DOCKETED	
Docket Number:	79-AFC-04C
Project Title:	Compliance - Application for Certification of DWR Bottlerock Geothermal Project
TN #:	266283
Document Title:	BRP_Response to DR2_Bio Resources_10022025
Description:	BRP_Response to DR2_Bio Resources_10.02.2025
Filer:	John C Casteel
Organization:	Mayacma Geothermal LLC
Submitter Role:	Applicant
Submission Date:	10/2/2025 11:03:34 AM
Docketed Date:	10/2/2025

RE: Response to Data Requests Set No. 2 – Bottle Rock Geothermal Power Plant (79-AFC-04C)

Enclosure Responses to Data Request Set No. 2 (79-AFC-04C)

Impacts Overview

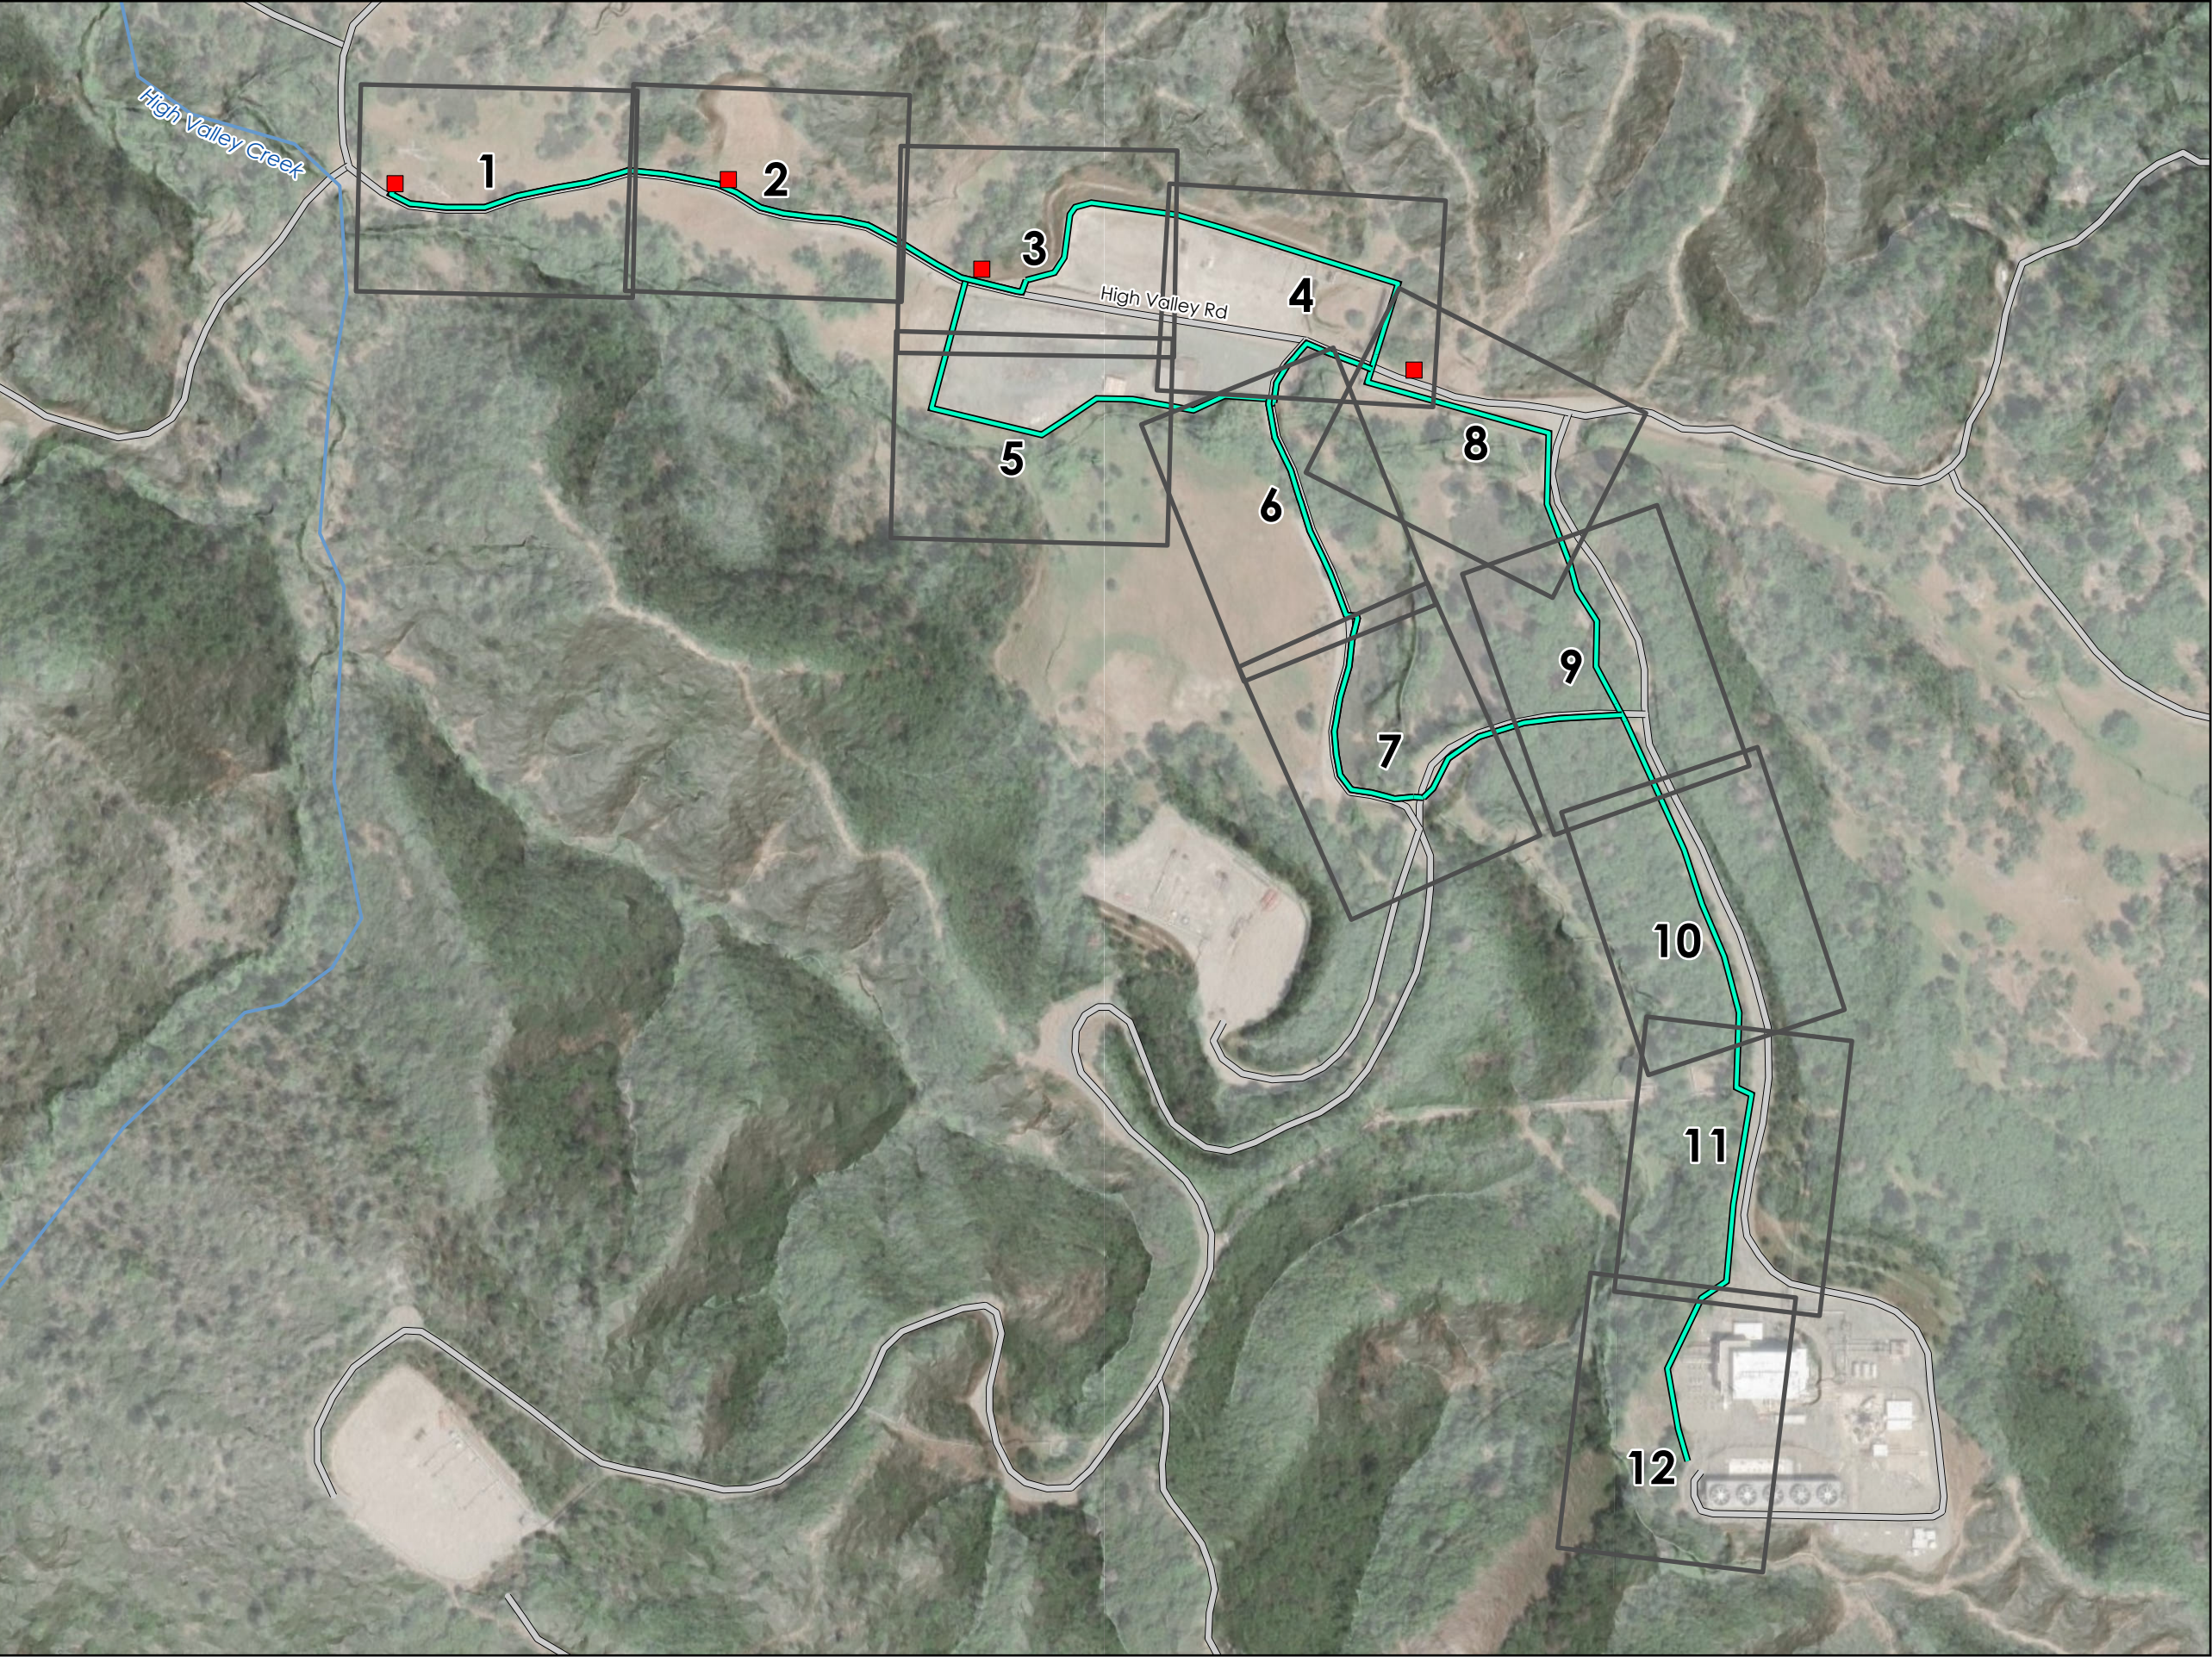
1. Provide the exact locations of permanent impacts such as groundwater supply wells and above-ground pipelines, and temporary impacts such as buried pipelines, access paths, or areas of vegetation removal. Alternatively, provide a maximum extent that CEC staff can use to determine project impacts to biological resources. Impacts should be classified as temporary impacts or permanent impacts.

2. Provide maps of permanent and temporary impacts, or the maximum extent of potential impacts.

The PTA included four optional locations for construction of the water supply well and additional options for routing of the pipeline to allow for flexibility in design and provide a maximum scenario for groundwater well construction. To allow for flexibility in final design, options are also provided for installing the pipeline on the ground surface or attaching the pipeline to existing steam pipeline supports along the existing access road and steam pipeline. The impacts from construction and operation of each well and each pipeline route/option are defined in Table 1 below and account for the maximum vegetation impact for each scenario (e.g., largest area of disturbance/most impact on vegetation) and the detailed maps that follow.

Detailed maps showing areas of permanent and temporary impacts including the maximum extent of potential impacts based on route options are included in the attached mapbook
